Re: Responses to Peer Review Comments  
Thorndike Place Traffic Impact Assessment  
Proposed 176-Unit Residential Development  
Arlington, Massachusetts

## **BETA Peer Review Letter – February 1, 2021**

Figure CR-1

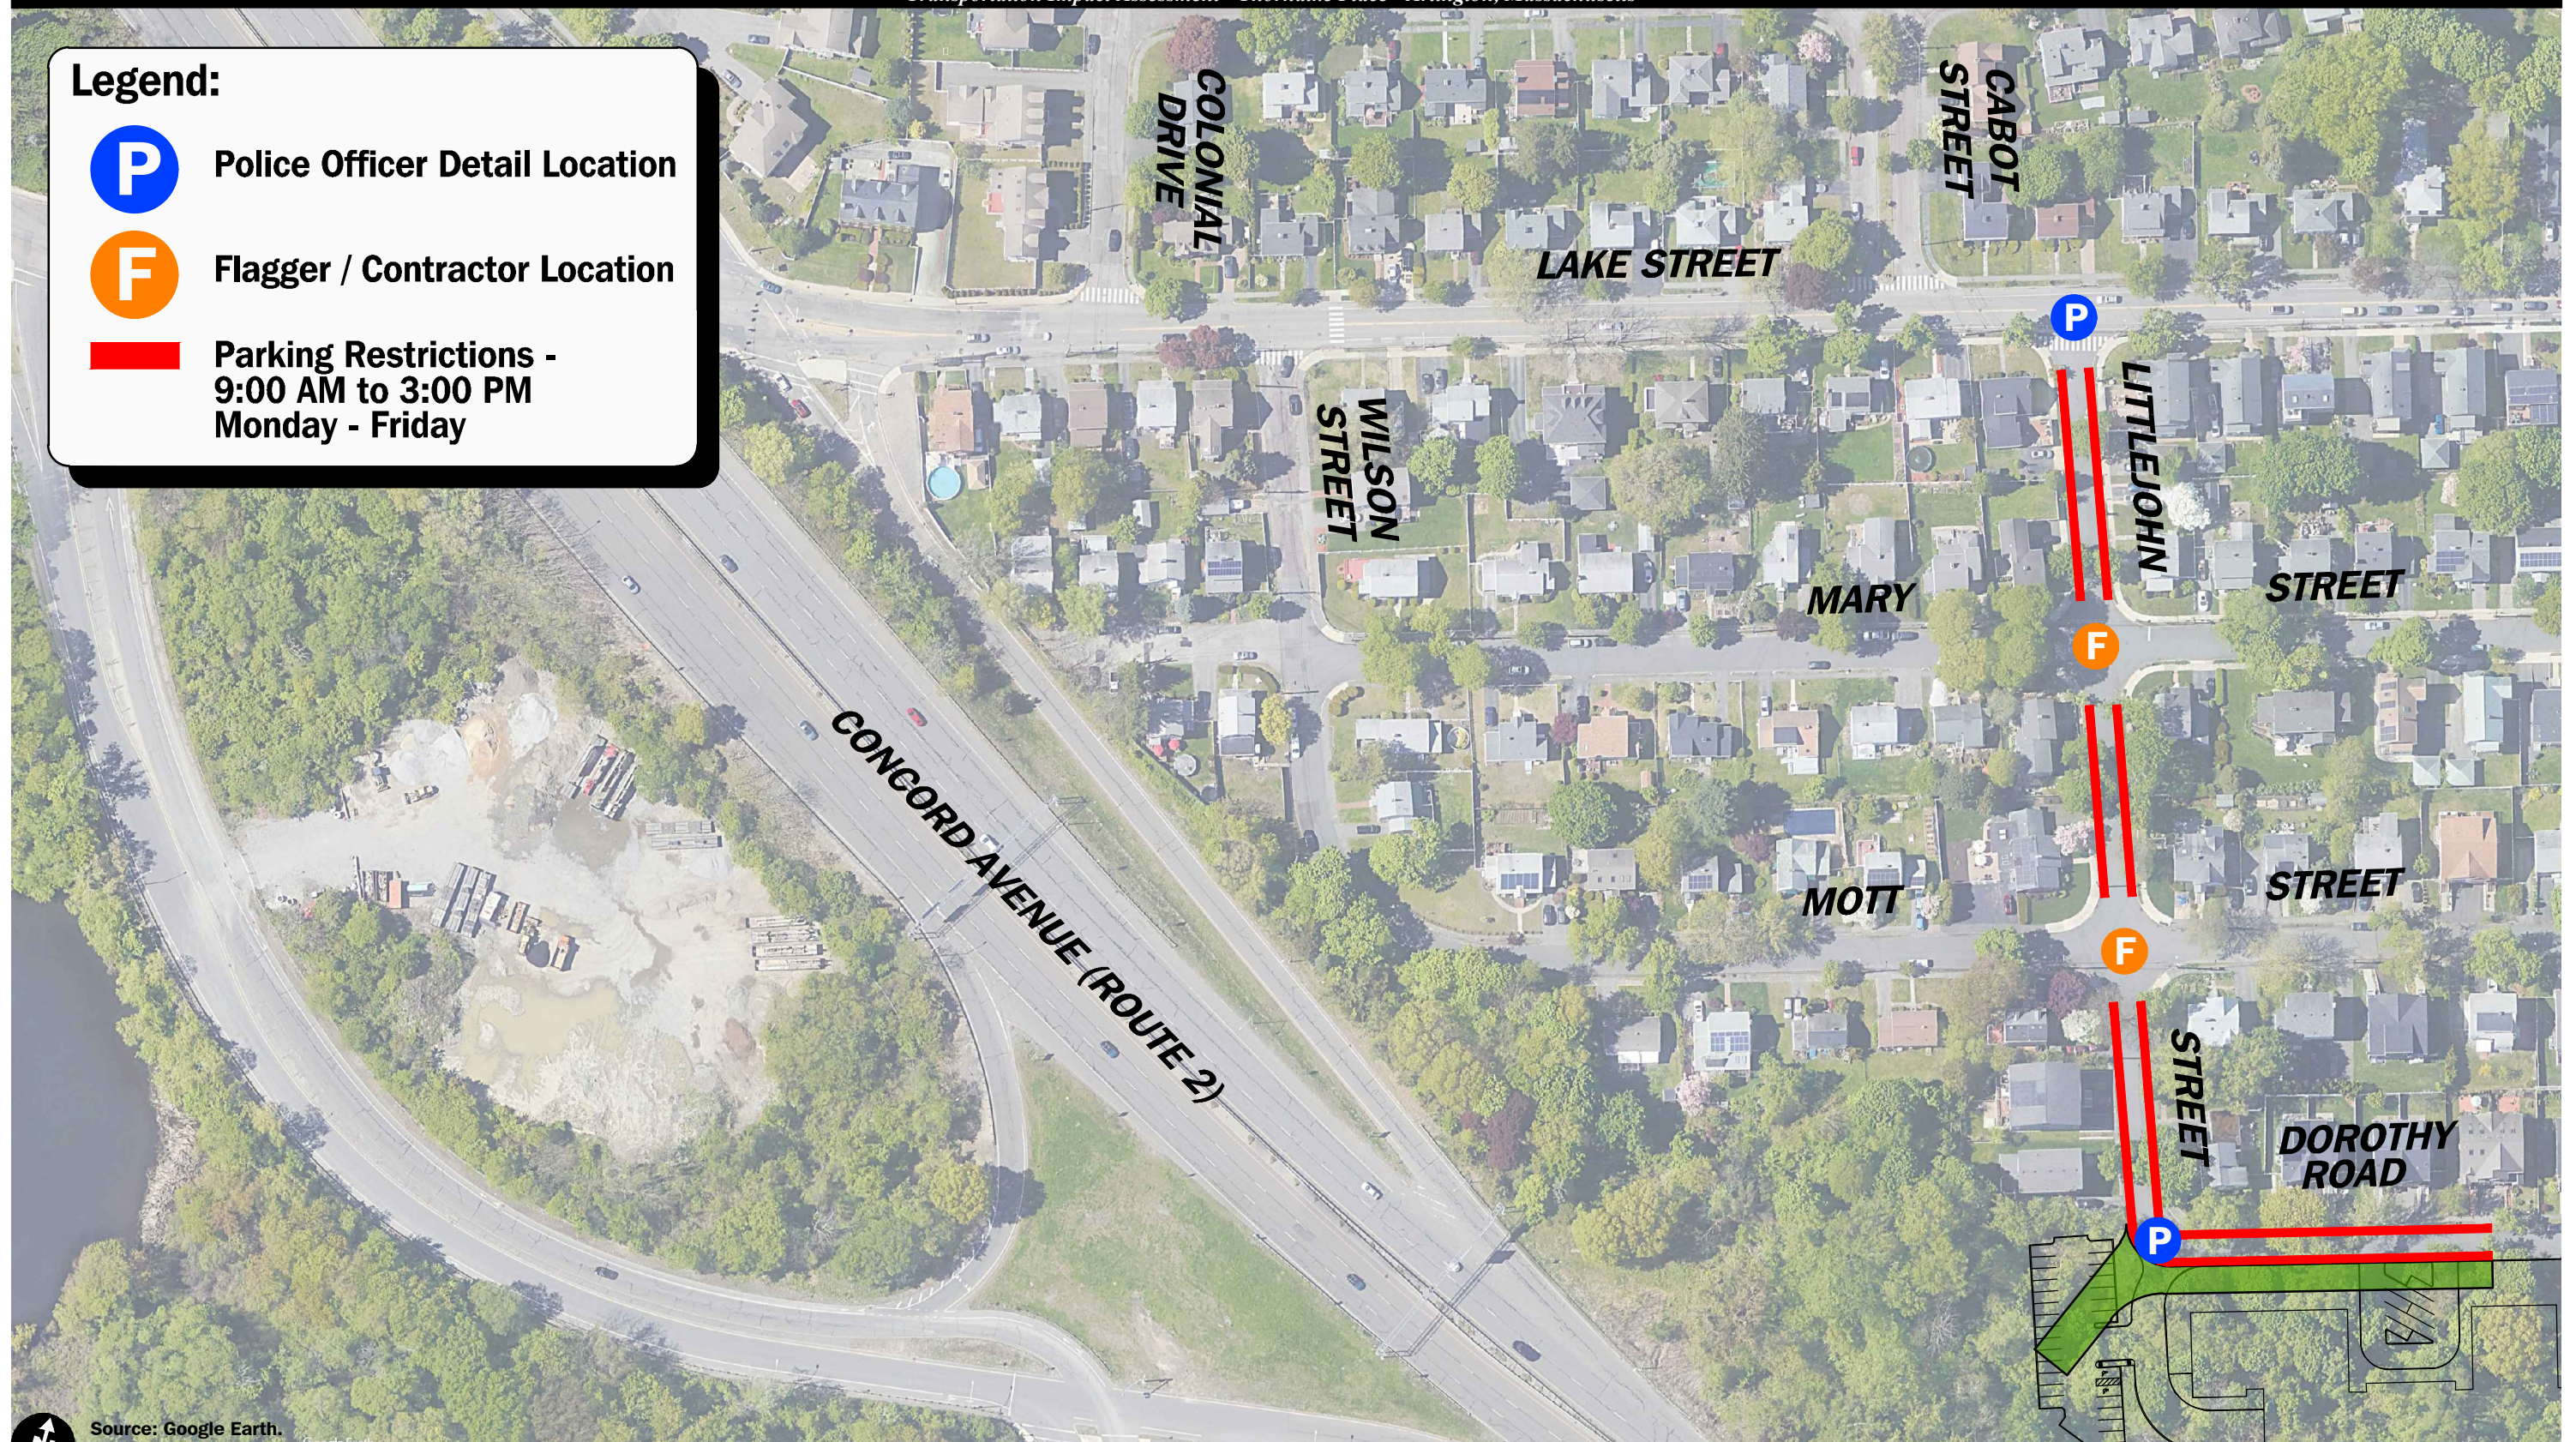
**Comment No. 41:** *BETA: “Quantify and analyze the effect of construction on the Dorothy Road neighborhood. It is expected that the earthwork required for the site will result in a significant number of trips for large dump trucks, in addition to other construction vehicles related to the grading and construction of the Site building. Verify turning path of large construction vehicles at affected intersections within the neighborhood and to/from Lake Street.”*

*1. Swept path analysis for the vehicle expected to transport modular units to the site. Swept paths should include turning from Lake Street to Littlejohn Street or other neighborhood streets, turnaround/backing path as required, and exit back to Lake Street.*

*2. Identify any parking or other access restrictions required along Lake Street or neighborhood streets to accommodate turning and vehicle access to the site.*

VAI has worked with BSC to provide preliminary estimates of truck traffic associated with the removal of soils associated with excavation for the garage and two subsurface drainage facilities. The estimated excavation is approximately 18,000 cubic yards. Assuming 10-yard dump trucks for hauling off site would result in the need for 1,800 dump truck loads. Assuming a 2 – 3-month duration, it would result in 25 – 38 trucks per day or 50 to 76 truck trips per day (one entering trip and one exiting trip per truck), six days per week.

With regard to the residential module deliveries, the Applicant has worked with multiple vendors in an effort to address construction impacts to the neighborhood. Accordingly, vehicle dimensions were provided and programmed into an AutoTurn analysis to identify vehicle swept paths at the intersections expected to be impacted, which include Route 2, Lake Street, Littlejohn Street, and the intersection of Littlejohn Street with Dorothy Road. This analysis is shown on Figure MT-1 and MT-2. In an effort to minimize the impact to the neighborhood, a staging area will be constructed on the site to allow trailers entering from Littlejohn Street to offload modules to the site, back into the site to reverse directions, and travel back via Littlejohn Street. Figure CR-1 indicates the proposed locations of police details and parking restrictions anticipated on the days of module deliveries.

Figure TC-2

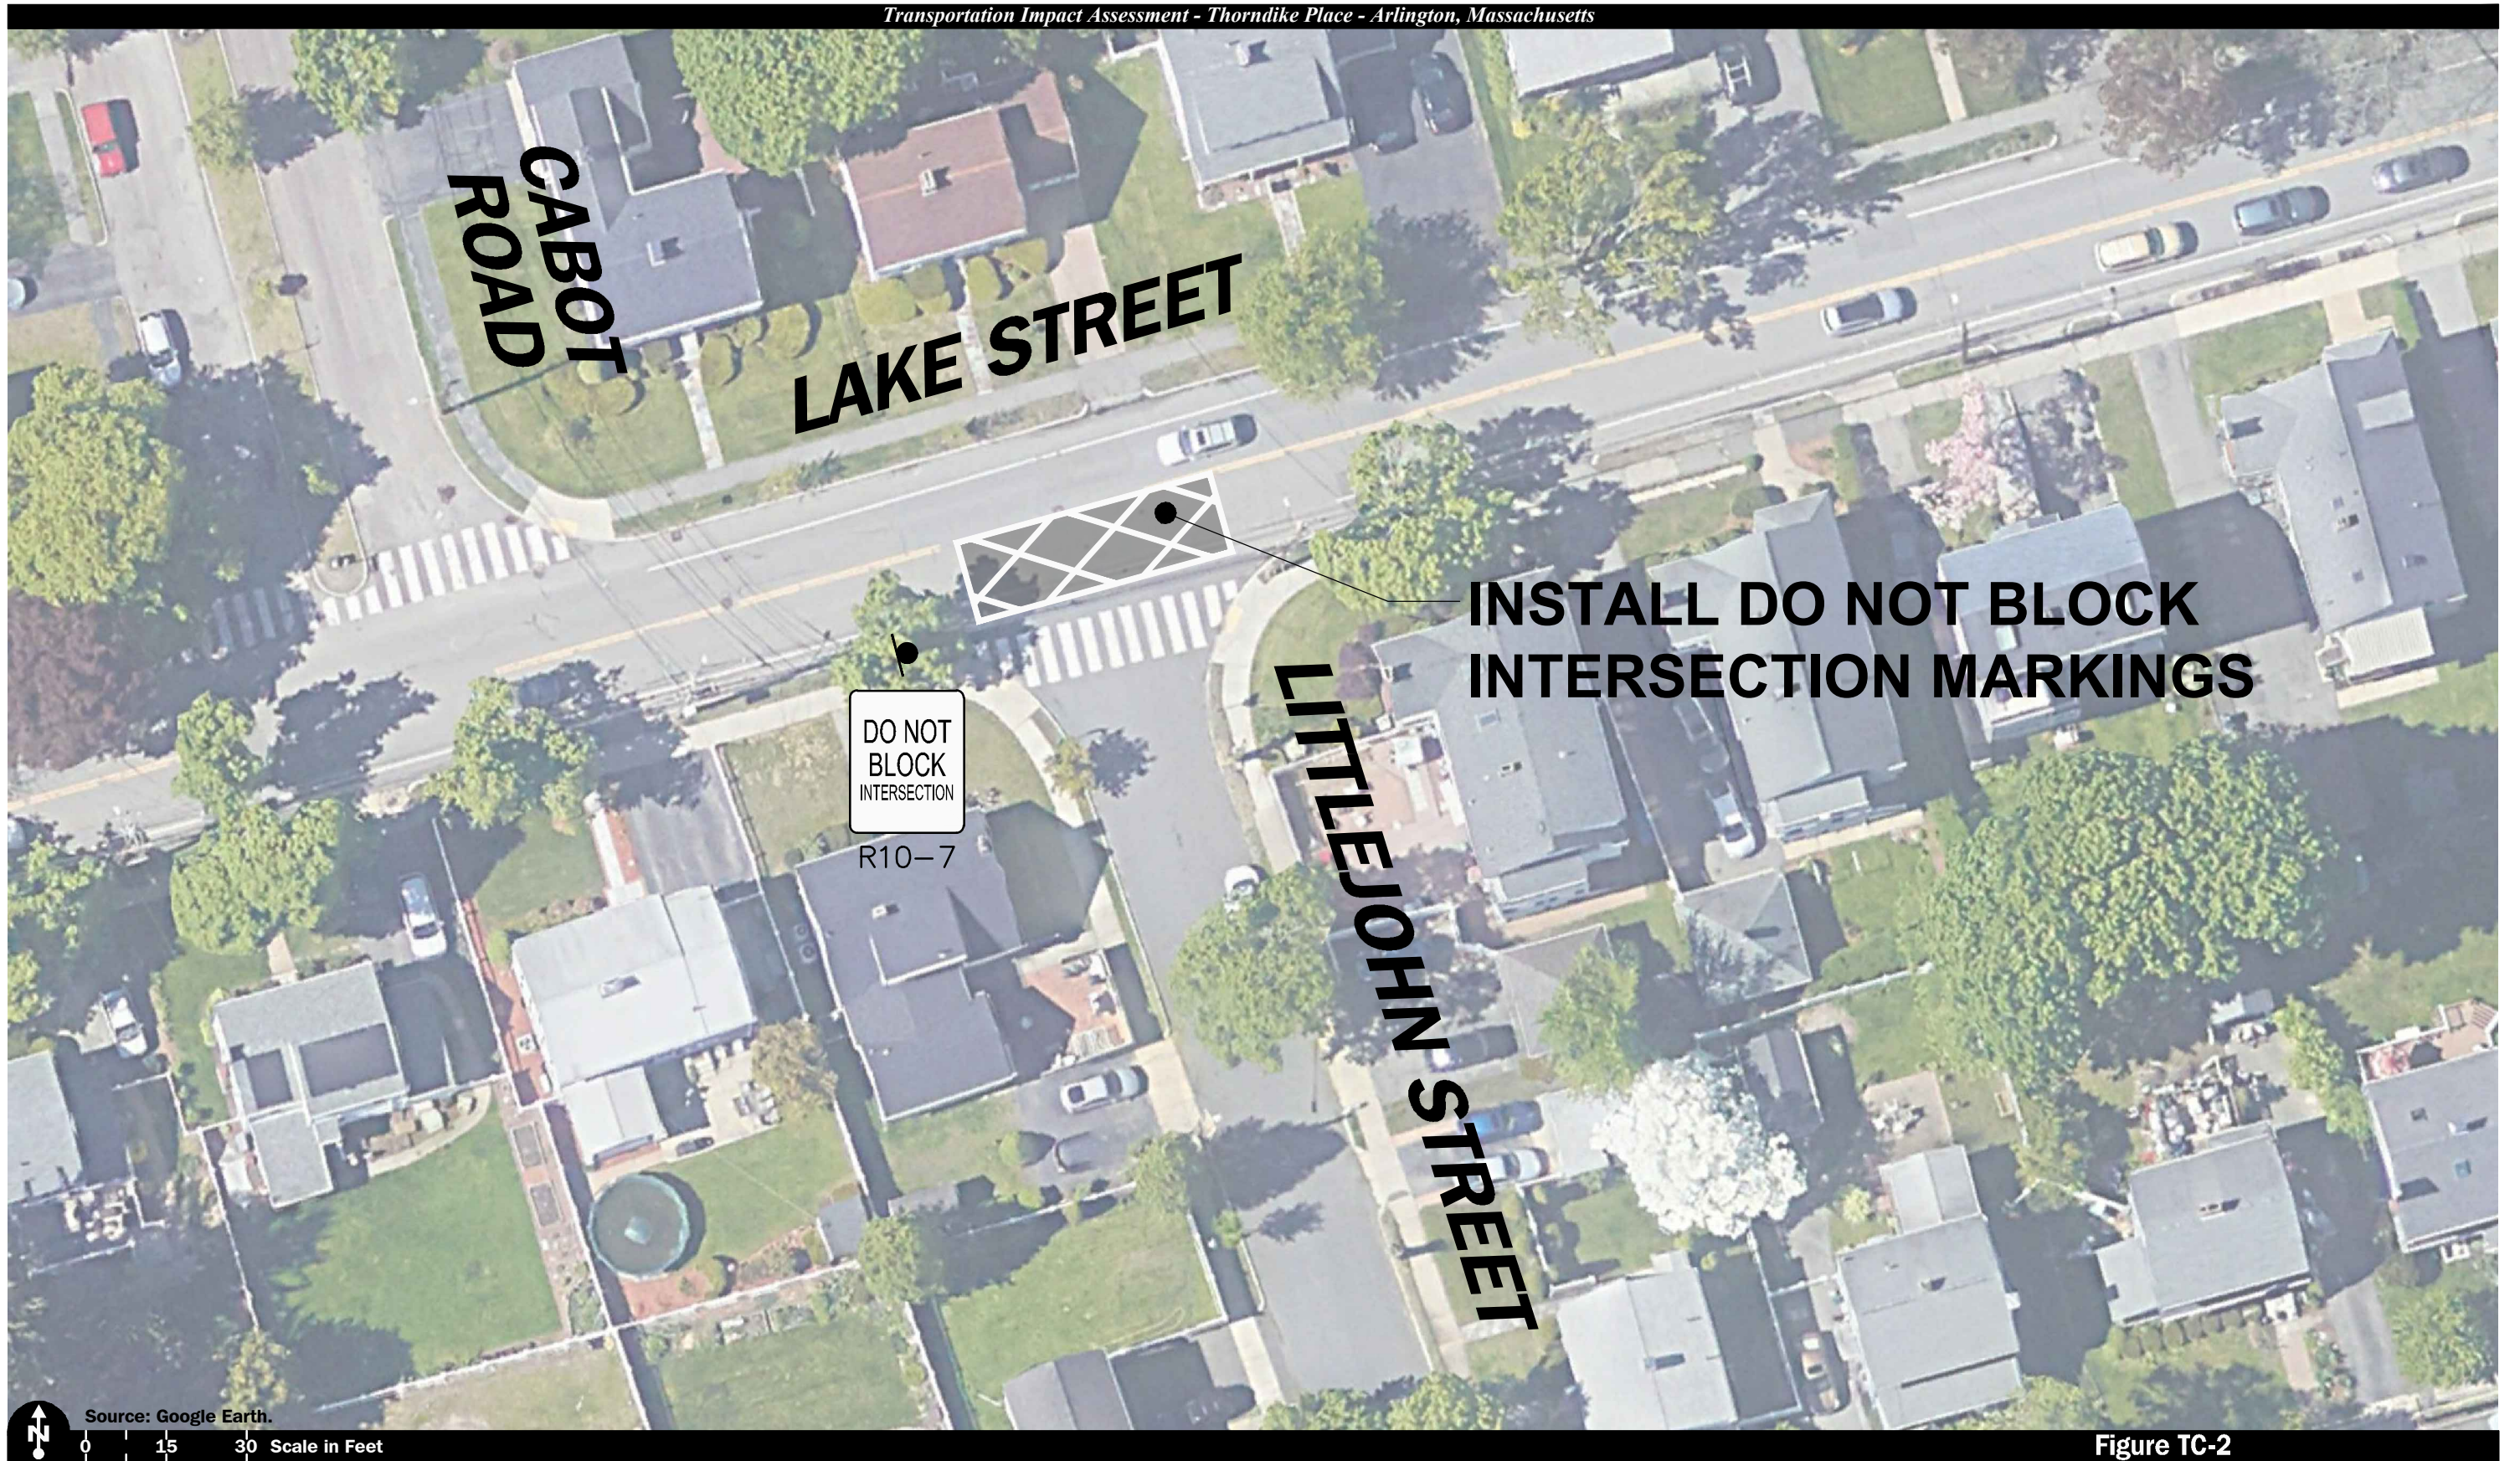
***BETA: "Recommend improving pedestrian crossing conditions, including ramps, warning panels, and crosswalks along the expected primary pedestrian route from the site to the Commuter Bikeway."***

**BETA: “Summary provided. Recommend improving pedestrian crossing conditions, including ramps, warning panels, and crosswalks along the expected primary pedestrian route to the Commuter Bikeway.”**

***BETA: “Discussion provided. As this will be the only reasonable pedestrian/bike connection, recommend upgrading the pedestrian infrastructure as required to provide a safe and accessible route.”***

In addition to the measures identified by BETA and agreed to by the Applicant, the Applicant has committed to the installation of a 23-dock Bluebikes station in the vicinity of the surface lot; committed to discussions with Zipcar to make available up to two surface parking spaces for Zipcars; and agreed to provide 176 covered and secure bicycle parking spaces in the garage. The Applicant has also agreed to provide “Do Not Block” intersection pavement markings at the intersections of Lake Street with Littlejohn Street, Burch Street, and Margaret Street, as shown on Figure TC-1 and TC-2.
